**195 District Park Pavilion
RFP I19561 - General Contracting Services
Addendum 003**

Responses to Requests for Information Due June 10, 2024

BSK-01

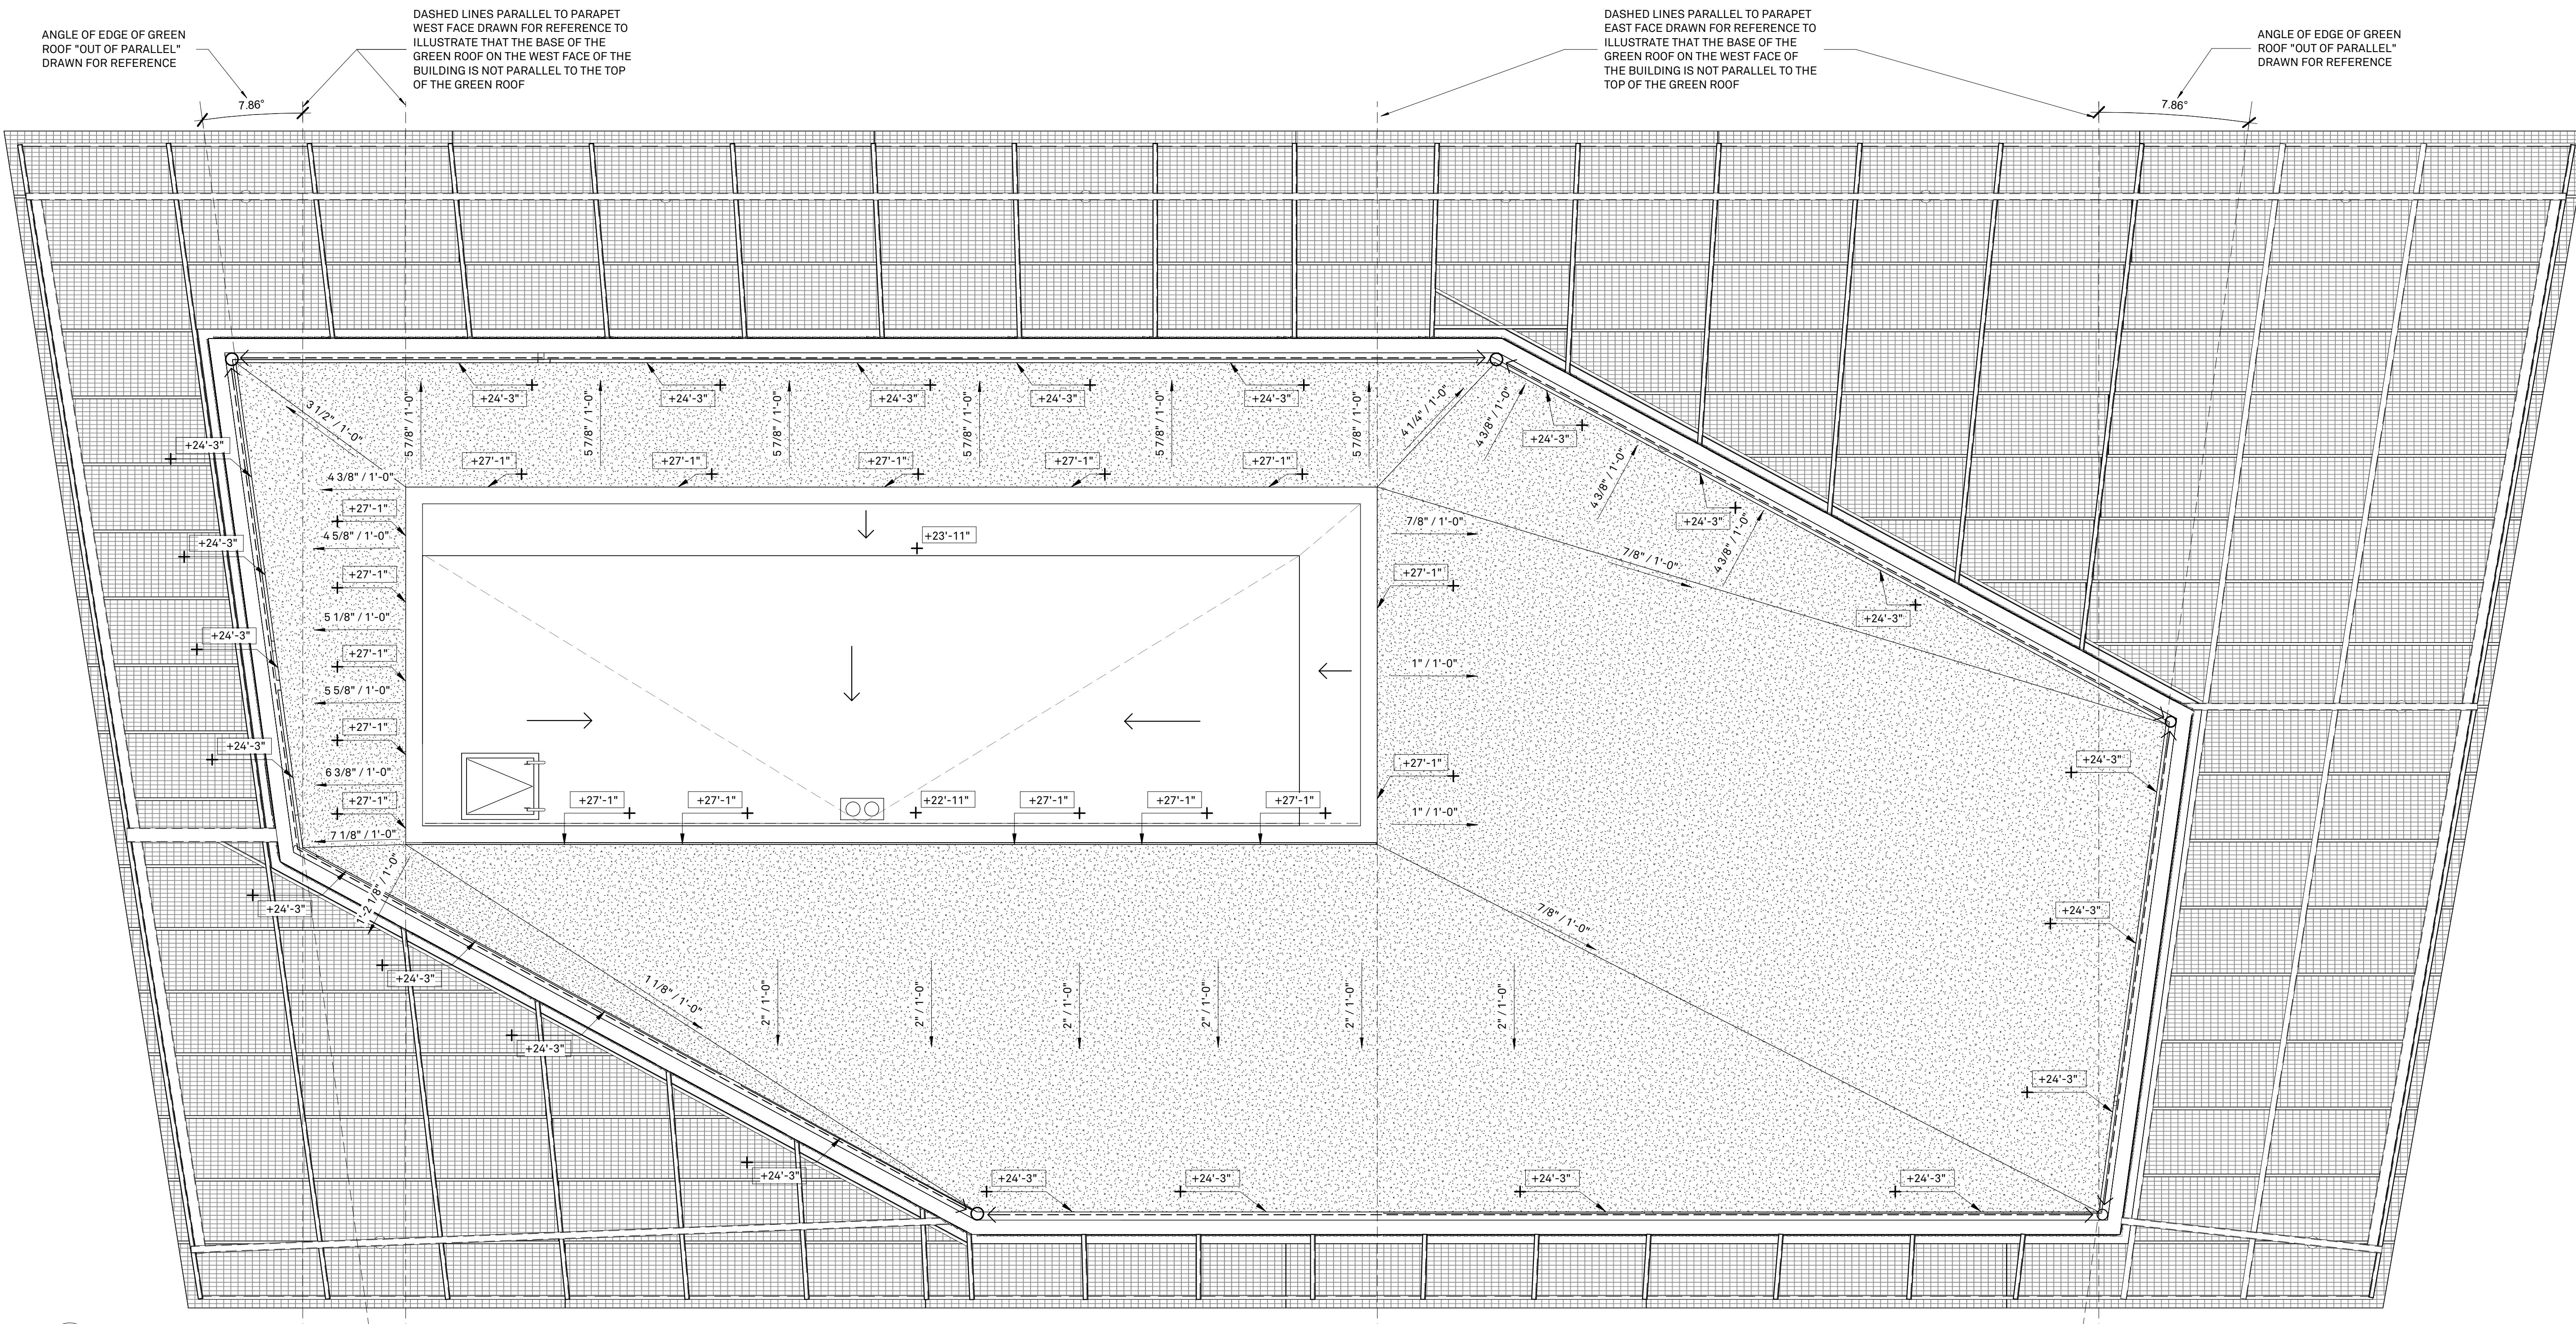
Q: Industry standards have established that a green roof installed over a roof slope exceeding 2"/12" requires an engineered slope stabilization system. Please provide the required engineered slope stabilization plan for all green roof areas with a slope greater than 2"/12". See attached mark-up on pages A-702 detail 2, A-604 details 1&3.

1. Flat structural plywood decking installed above the building's steel and wood roof structural elements
2. Built-up roof insulation to produce the green roof shape and slope
3. A PVC roof membrane
4. A layer of pre-planted green roof trays

Pre-planted trays bear against the perimeter roof curb by virtue of a PVC pipe rail assembly as indicated in 1/A-606. The planted trays interlock with one another using LiveRoof's WindDisc system as indicated in the project manual. Additional green roof support elements required to realize the intended green roof design are to be provided by the contractor and/or their subcontractors as a matter of delegated design to be coordinated with the building structure and roofing assembly. Related work will be subject to typical submittal protocols and will be subject to review by members of the design team as appropriate.

The noted "engineered slope stabilization plan" is unfamiliar to our contacts at LiveRoof. Outreach to the authors of this RFI did not produce additional information about how this might apply to this project. Our independent research of this item found engineered slope stabilization plans to largely refer to civil engineering projects whose extents differ greatly from the proposed green roof.

The specified manufacturer, LiveRoof, has successfully produced sloped green roofs at slopes greater than 2"/12" using their pre-planted tray systems.

- A: The specified manufacturer, LiveRoof, has successfully produced sloped green roofs at slopes greater than 2"/12" using their pre-planted tray systems. Pre-planted tray systems, in their perspective, by their very nature provide a degree of structure to the green roof. Built-in-place systems, in their perspective, have a tendency to require more numerous supports (when required at all) that produce more numerous and frequent roof membrane penetrations and flashing. Given the previous notes, the design team prefers the specified pre-planted green roof tray system with additional supports as required to achieve the design. Additional green roof support elements required to realize the intended green roof design are to be provided by the contractor and/or their subcontractors as a matter of delegated design to be coordinated with the building structure and roofing assembly. Related work will be subject to typical submittal protocols and will be subject to review by members of the design team as appropriate.

- Any green roof system utilized on the project should be approved by and installation coordinated with the roofing manufacturer. The design team is amenable to alternate green roof systems that achieve the intended design and provide the intended soil depth and planting if the specified system is determined to be incapable of achieving the intended design.
